LAKE PONTCHARTRAIN, L.A.
AND VICINITY
**LAKE PONTCHARTRAIN
HIGH LEVEL PLAN**

**DESIGN MEMORANDUM NO. 20
GENERAL DESIGN**

**ORLEANS PARISH
JEFFERSON PARISH
17th. St. Outfall Canal
(Metairie Relief)**

CELMV-ED-PG (CELMN-ED-SP/15 May 90) (1105-2-10c) 3d End
Mr. Eckenrod/ts/5925
SUBJECT: Lake Pontchartrain, Louisiana and Vicinity, High Level Plan, Design
Memorandum No. 20 - General Design, 17th Street Outfall Canal

ENCL. 27

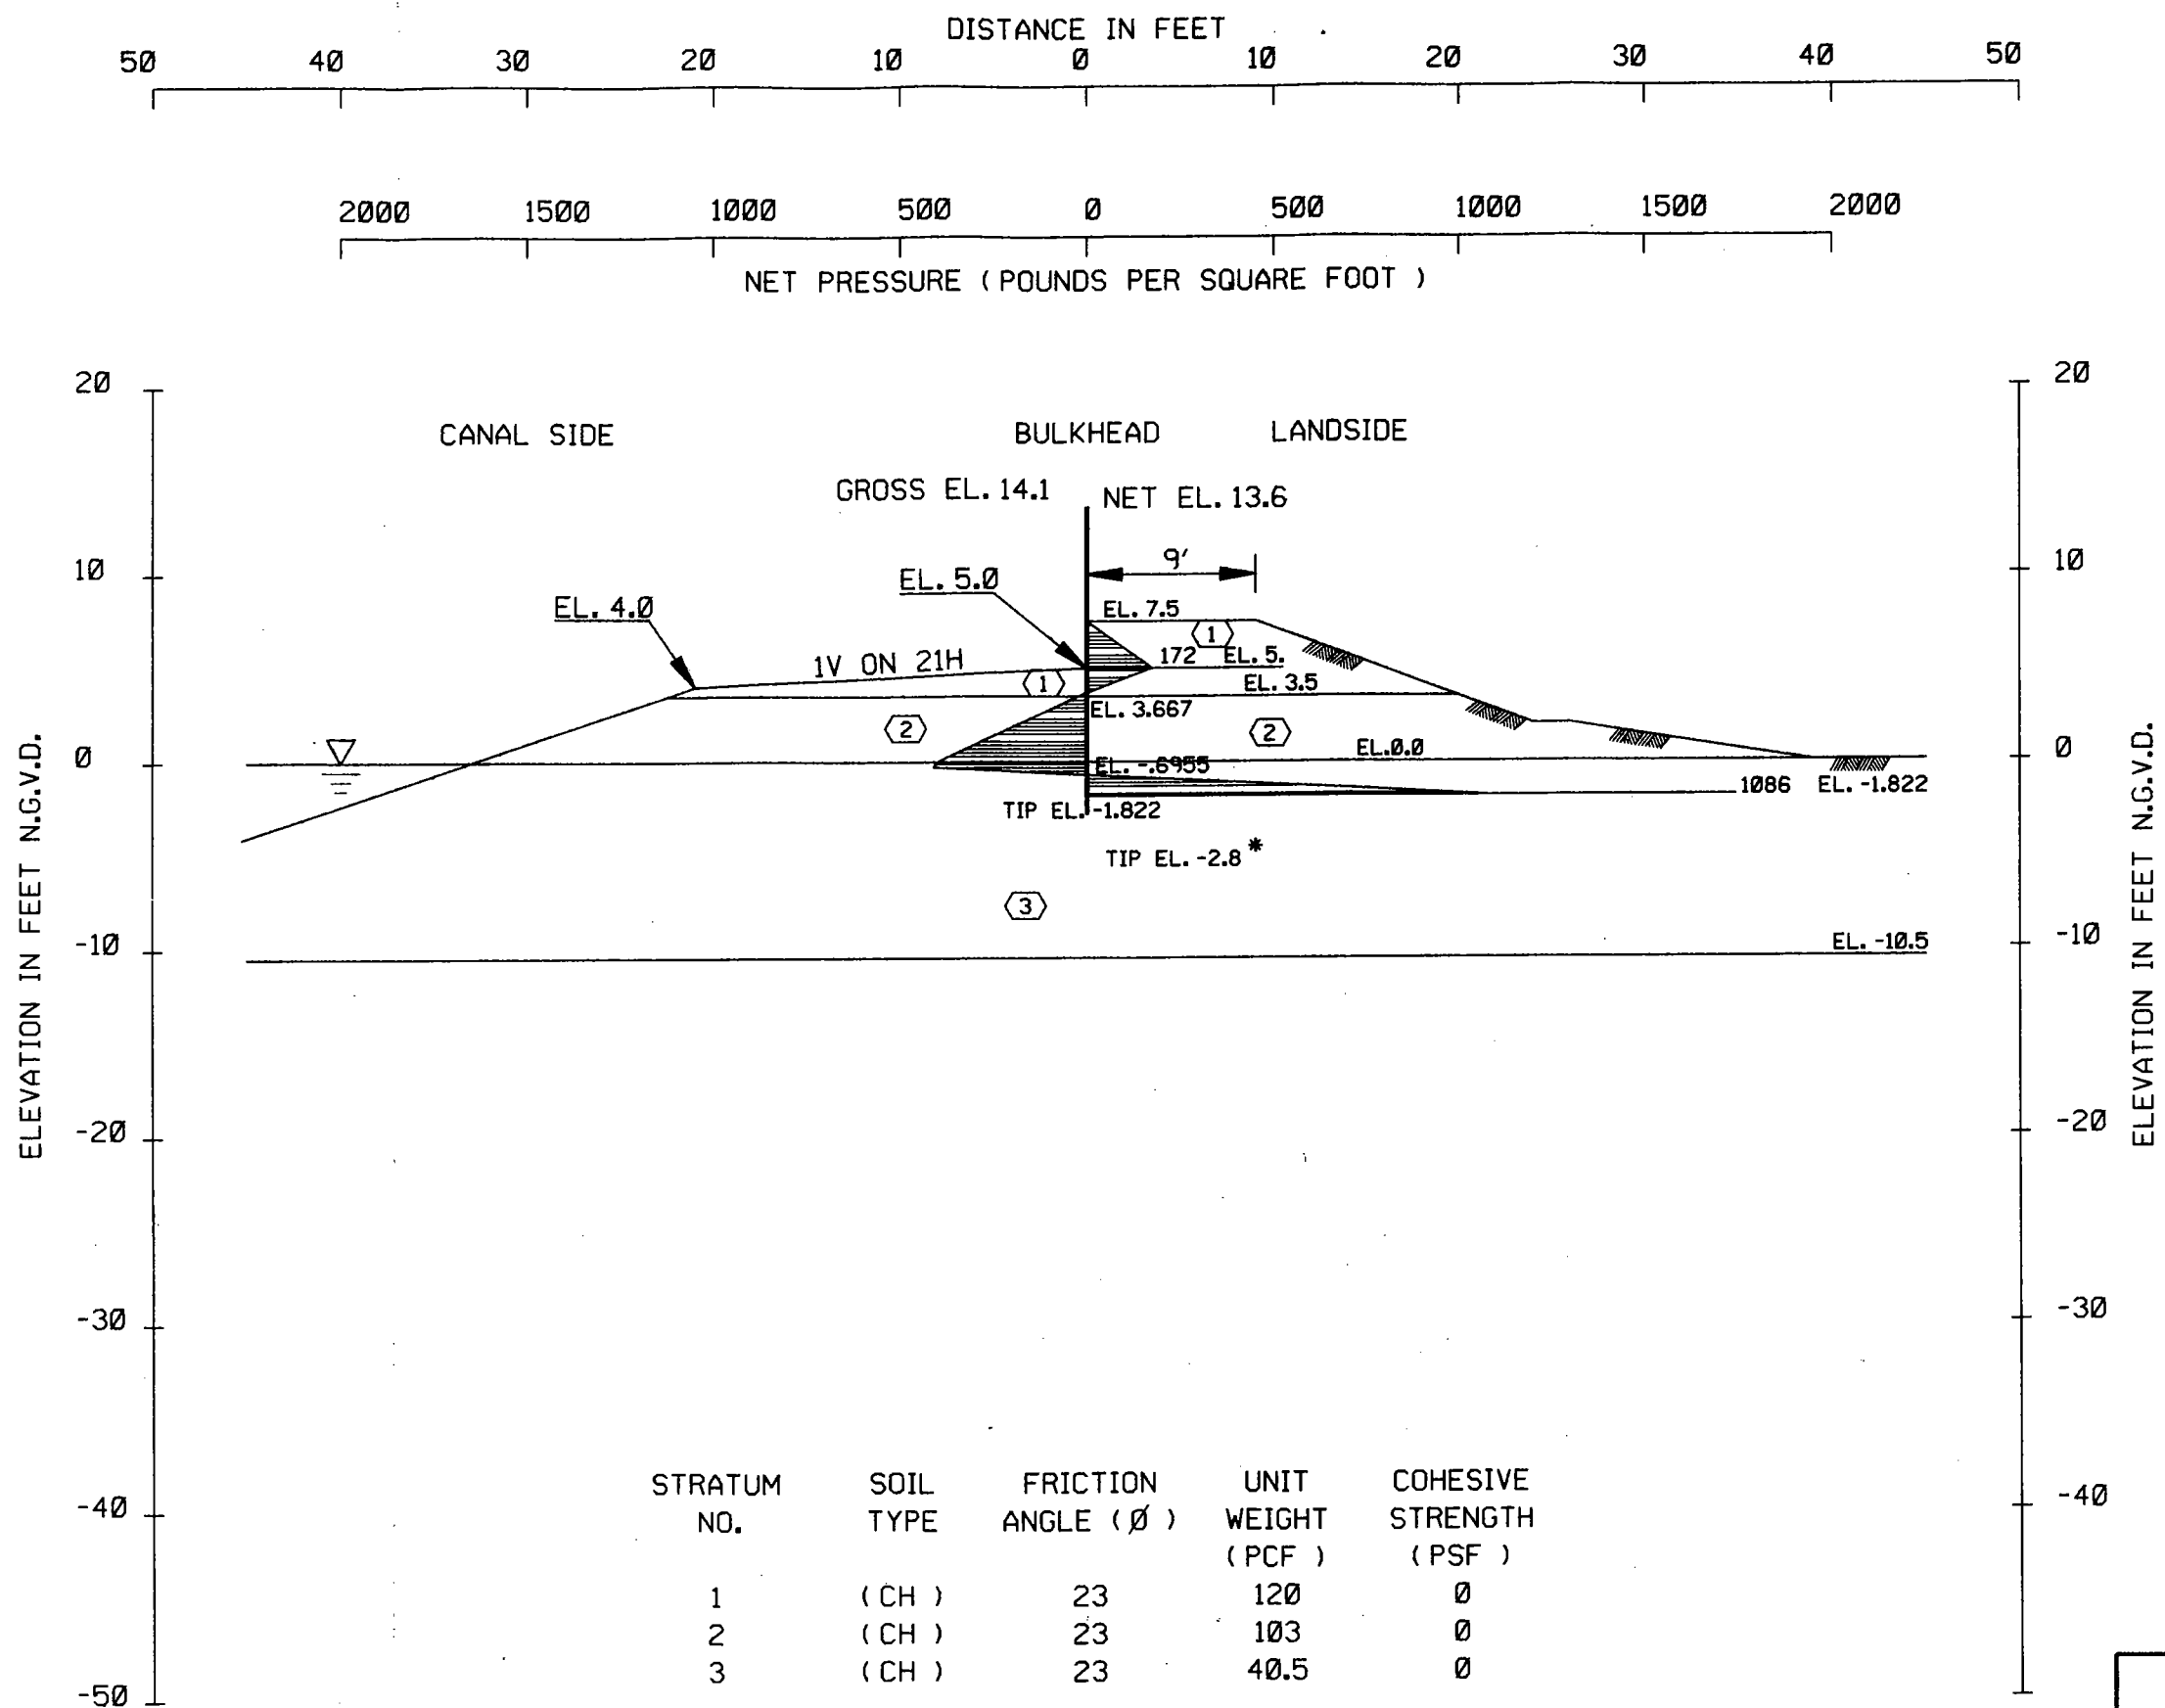
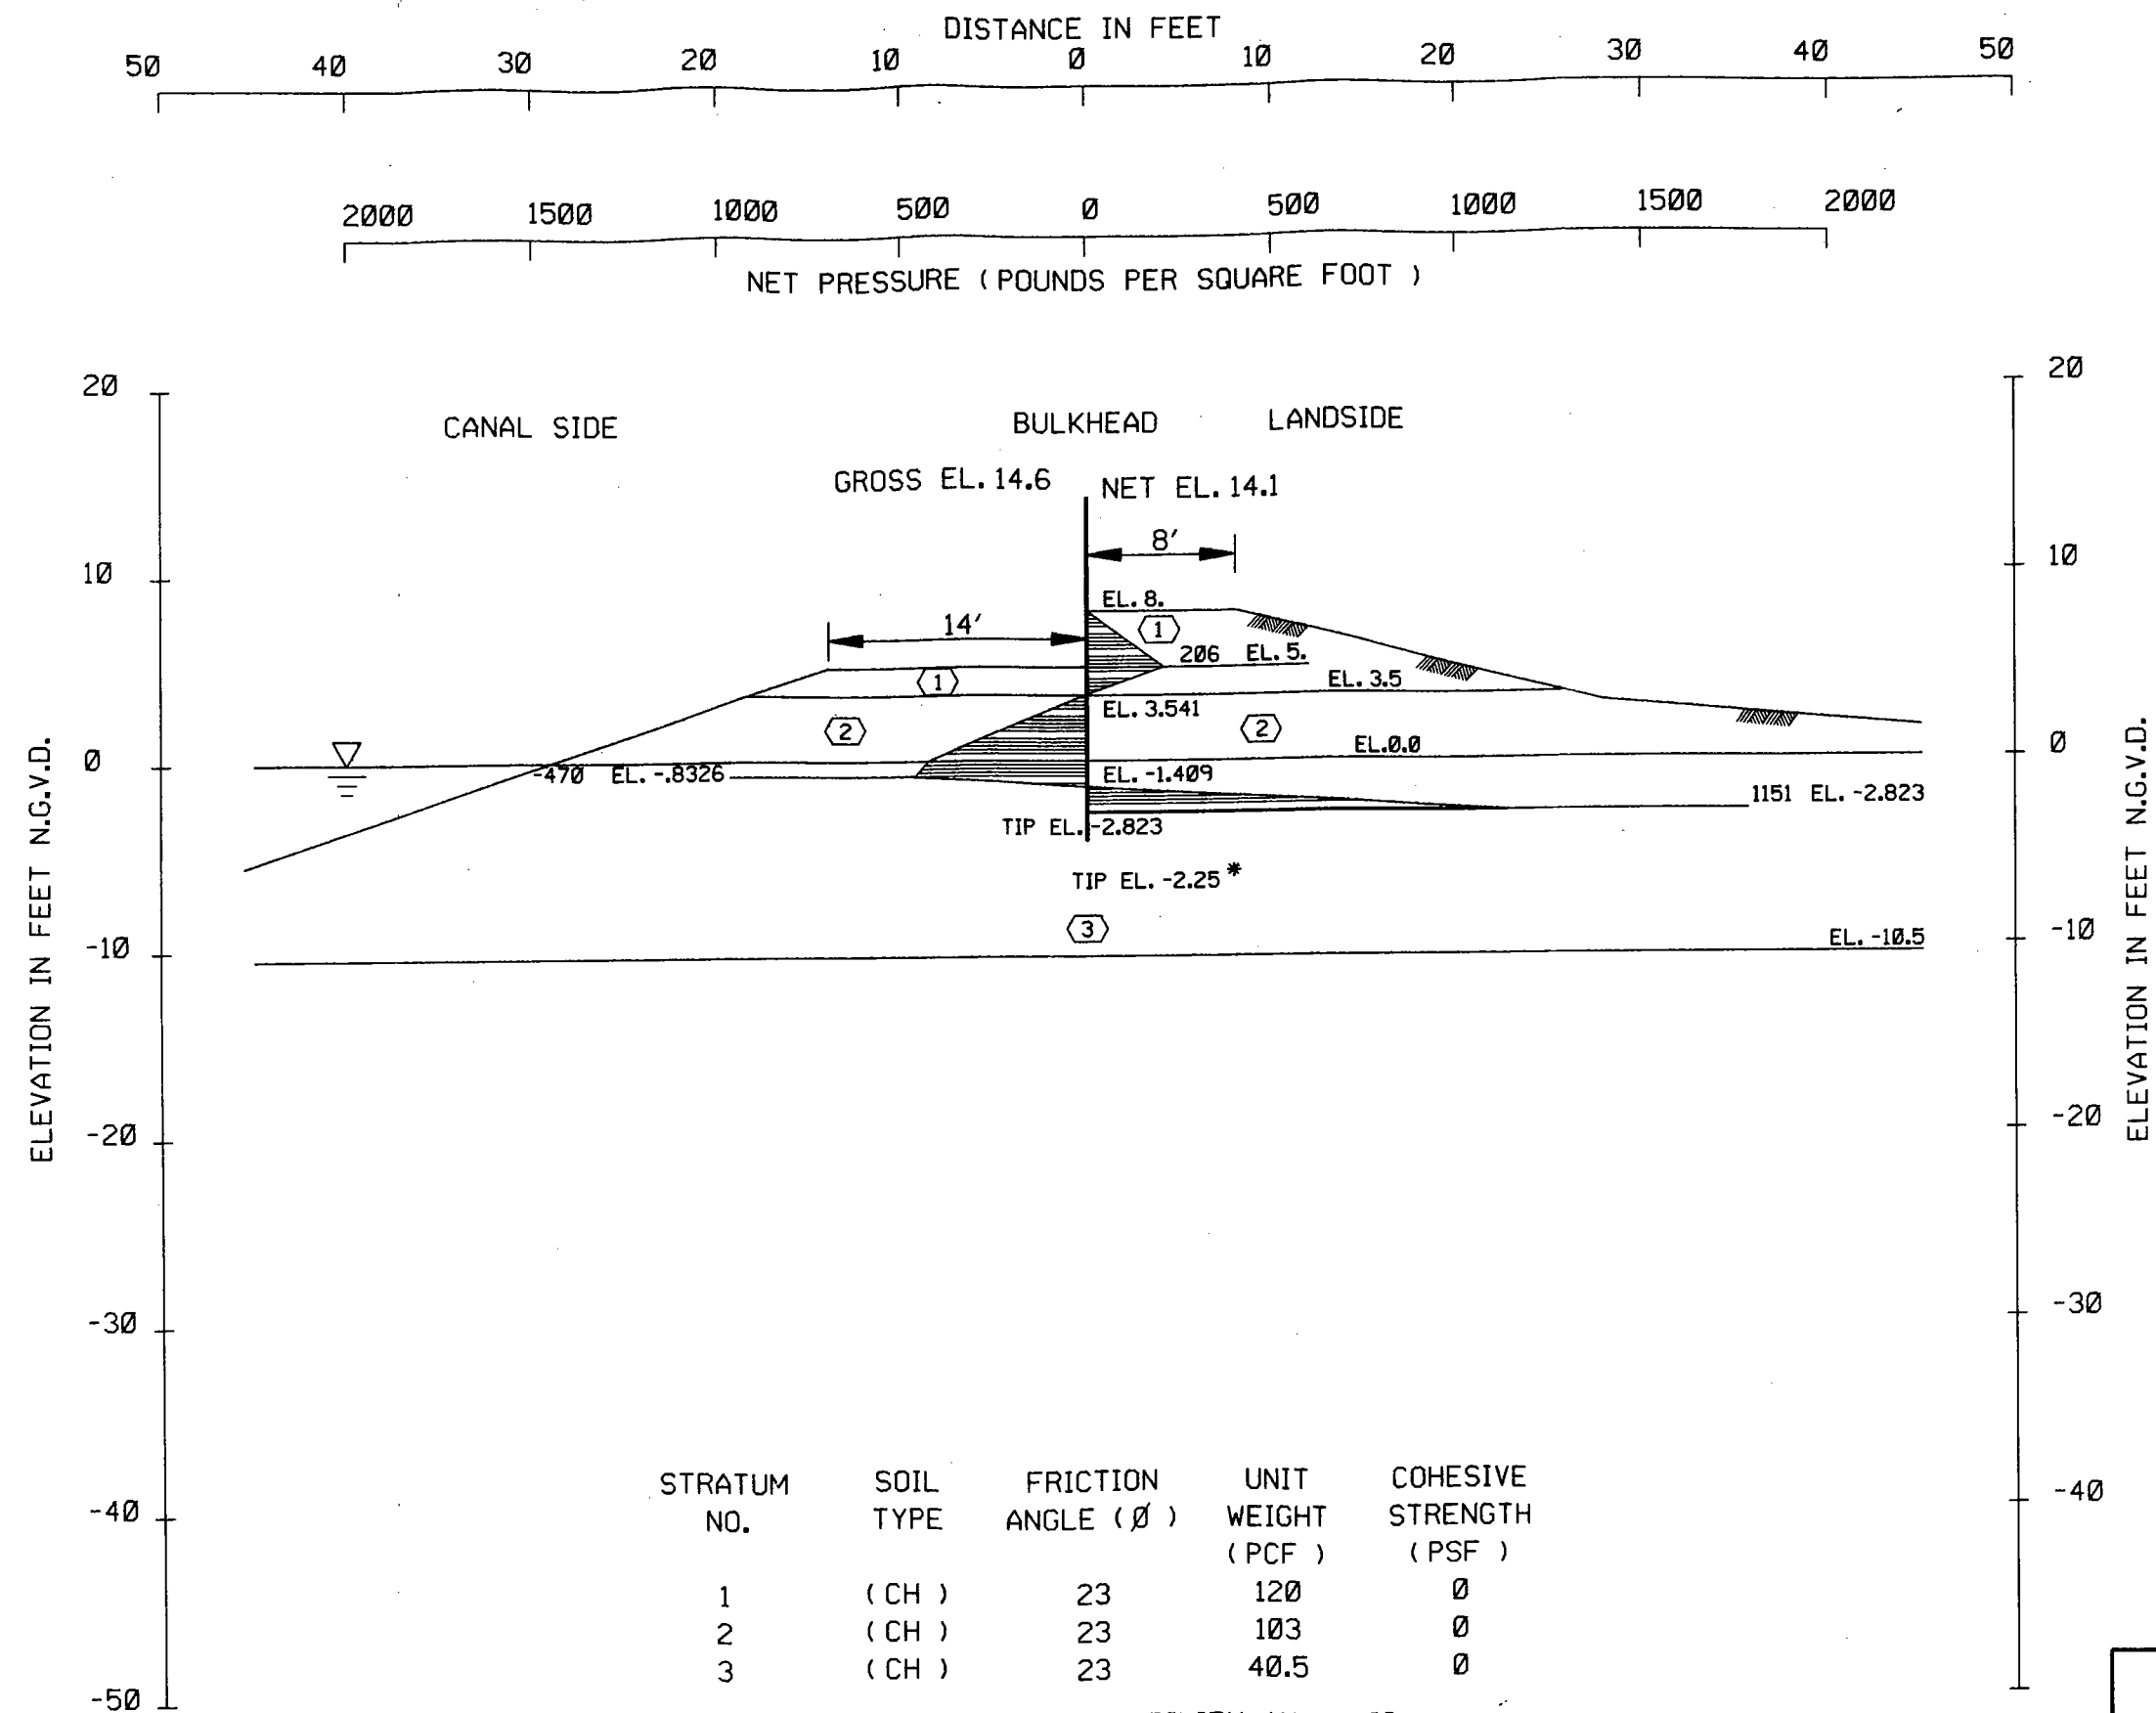
d. Para 29c. Also refer to the tied back and braced wall analyses on Plates 121-124. These analyses are based on the "Q" case soil strengths, a canal level at el -5.0, and a factor of safety of 1.5. Since these sheet pile bulkheads permanently retain soil, they should also be analyzed using "S" soil strengths, a factor of safety of 1.5, and at the normal canal level of el 0.0.

m. Plates 121 through 124. The walls shown on these plates should be evaluated for the anchor forces and resulting stresses on the anchors and the sheet piling should be checked using the conditions shown except change the water level on the canal side to el 0.0 NGVD and use soil properties for the 'S' case and a F.S. = 1.5.

d. Comment d. Para. 29c. The analyses presented were for the Q-CASE soil strengths, a canal level at EL. -5.0 and a factor of safety of 1.5. For plates 121, 122, and 124 the actual design (completed before Dec 87) was controlled by the S-CASE, F.S. = 1.5, and canal level at EL -5.0. The design on plate 123 (completed after Dec 87) was based on the S-CASE F.S. = 1.2 with canal level at EL -5.0; S-CASE F.S. = 1.5 with canal level at EL 0.0; or the 3:1 penetration to head ratio. All the braced walls and tieback walls have been constructed. The tip penetrations shown on plates 122-124 are deeper than the minimum required tip penetration (Encl 3). Intermediate tip penetrations were used to reduce the anchor forces.

m. Comment m. Plates 121 through 124. Concur. Revised plates 121 through 124 are enclosed as Encl 3.
